Re: Tule Wind Project - Response to Data Request No. 6

Response to Data Request No. 6

1. Geology - Active Fault

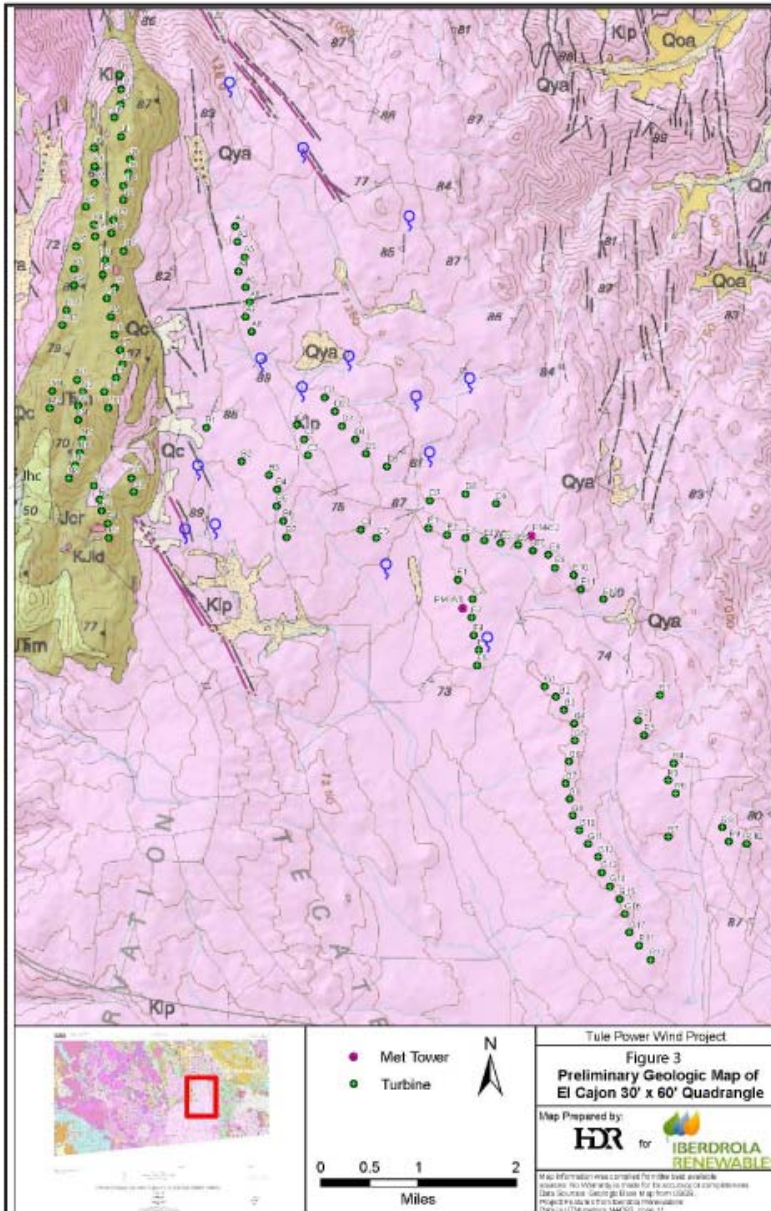
There is a discrepancy between which towers are located near a potentially active fault between the Geologic Hazards Assessment (January 2010) and the Geology, Soils, and Minerals section of the Applicant's Environmental Document. The Geologic Hazards Assessment indicates towers B1 – B7 are near this fault and the Applicant's Environmental Document states that it is near towers Q1 and Q2. Please clarify which turbines would be affected by the potentially active fault.

In this evaluation, the potential impact from active faulting is limited to the likelihood of fault offset in the tower foundation. The towers with identified potential for impacts from the presence of a potentially active fault are towers Q1 and Q2. This potential impact is based on a hypothetical northwesterly extension of the potentially active fault which might pose a risk for fault offset in either of these two tower foundations. With this interpretation, the other nearby towers (B1 – B7 and P1 – P5) would be subject only to seismic shaking. As referenced in the AED, tower design, including foundation design, can effectively mitigate the risk from seismic shaking. Additional field geologic mapping is recommended during design efforts to further define these potential impacts.
